NOTICE OF FINAL PUNCH LIST AND DEFECTIVE ITEMS

Project Name: SW 2nd Avenue Median Parking

Project #: 12381

FINAL SITE INSPECTION REPORT

DRAWING # PGD-1
 SHEET 17
 TOTAL: 16
 CAD FILE: 12434-PGD
 DRAWING FILE NO: 4-141-42

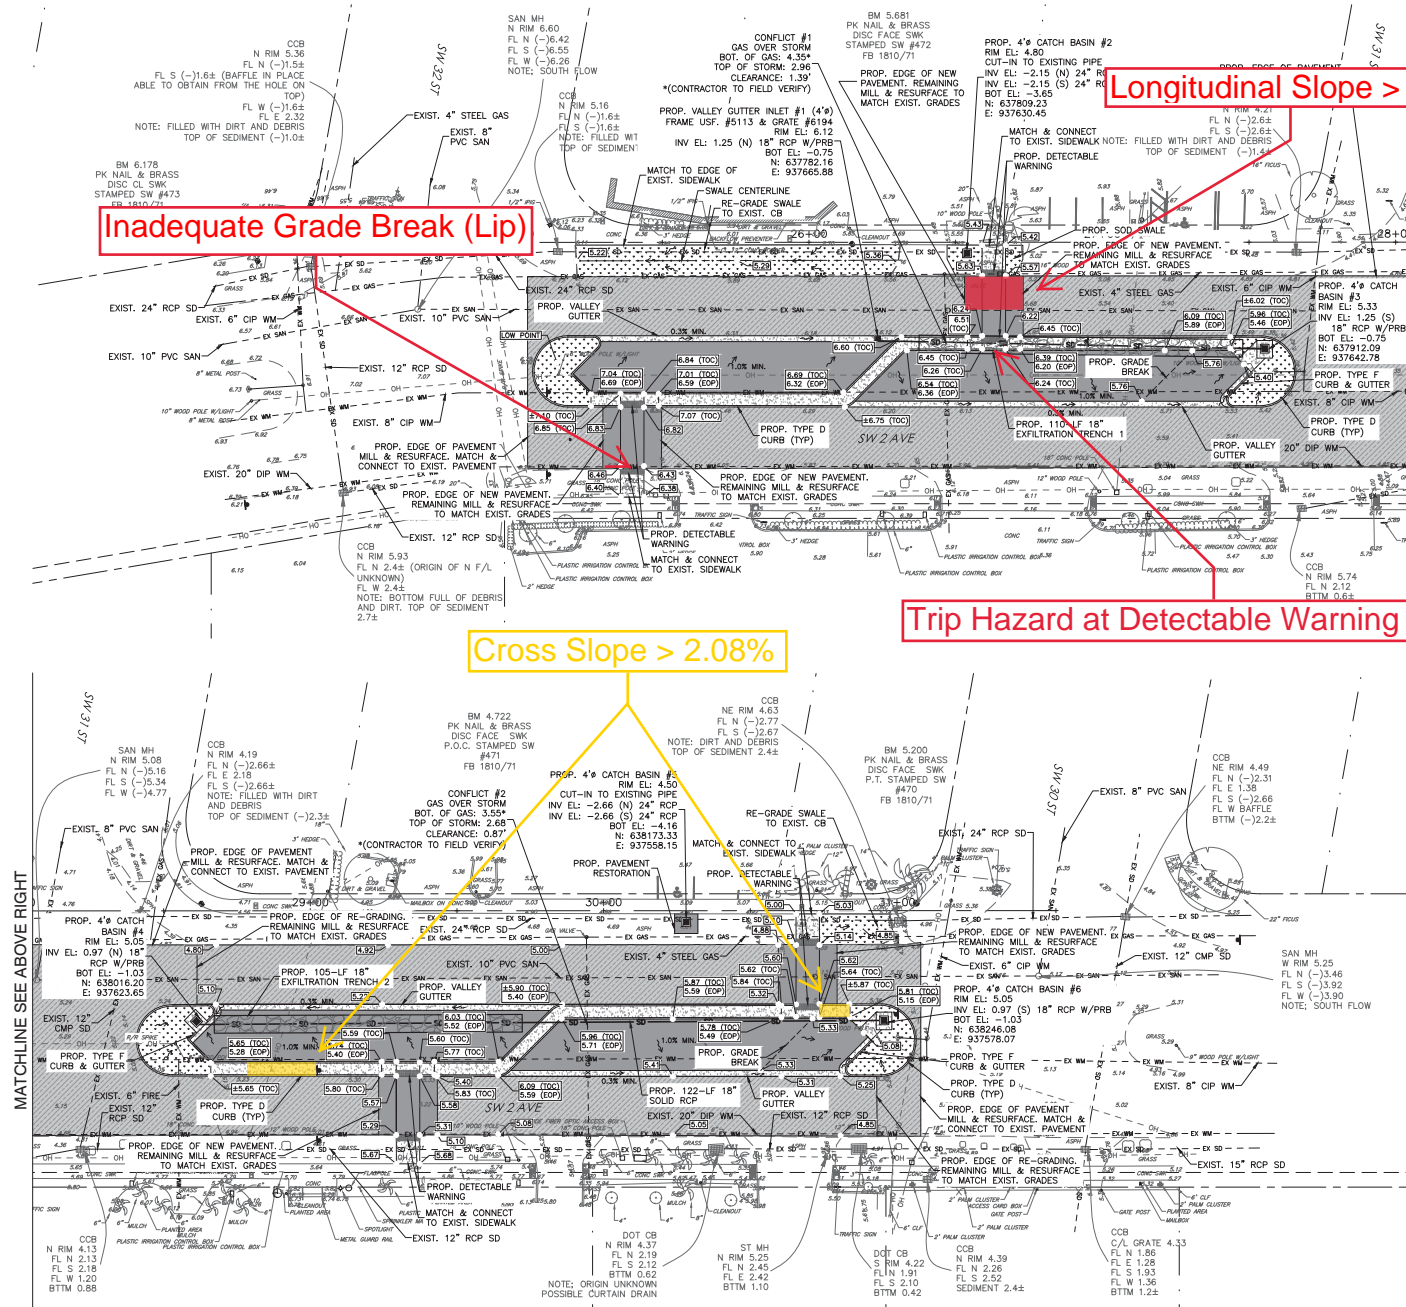
CONTRACTOR failed to comply with ADA cross slope of accessible routes walking surfaces requirements. The cross slope of walking surfaces shall not be steeper than 1:48 (2.08%). Portions of the sidewalk cross slope within the North median of SW 2nd Avenue were measured and recorded to be out of compliance.

Changes in level between ¼ inch and ½ inch shall be beveled with a slope not steeper than 1:2. CONTRACTOR failed to install detectable warning surfaces flushed with the abutting concrete sidewalks.

CONTRACTOR failed to comply with ADA running slope of accessible routes walking surfaces requirements. The running slope cannot exceed 1:20 (5%). The South raised crosswalk of SW 2nd Avenue Southbound right lane longitudinal slope is greater than 5%. The slope was measured at 7.5% - 8%, which represents a rise of approximately 9-inches in a 10-foot run.

CONTRACTOR failed to provide adequate grade break or smooth transitioning between raised crosswalk and concrete sidewalk. Uneven surfaces were identified on the South raised crosswalk of SW 2nd Avenue Northbound right lane grade break with existing sidewalk. No lips or other variations in slope within runs are allowed, as they can disrupt wheelchair travel.

Inadequate Grade Break (Lip)

Longitudinal Slope > 5%

Portions of accessible routes with running slopes steeper than 5% must be treated as ramps. Handrails must be provided on both sides if rise is greater than 6"

Trip Hazard at Detectable Warning Surface

Cross Slope > 2.08%

Corrective actions shall be submitted and approved by the CITY before being performed. Grinding of the concrete surface is not acceptable as it may expose the concrete aggregates, compromising the durability of the structure.

Portions of accessible routes with running slopes steeper than 5% must be treated as ramps as prescribed in the ***United States Access Board Guideline – Chapter 4: Ramps and Curb Ramps***. Ramps running slope cannot exceed 1:12 (8.33%). Ramps must be equipped with handrails at both sides if rise is greater than 6 inches.
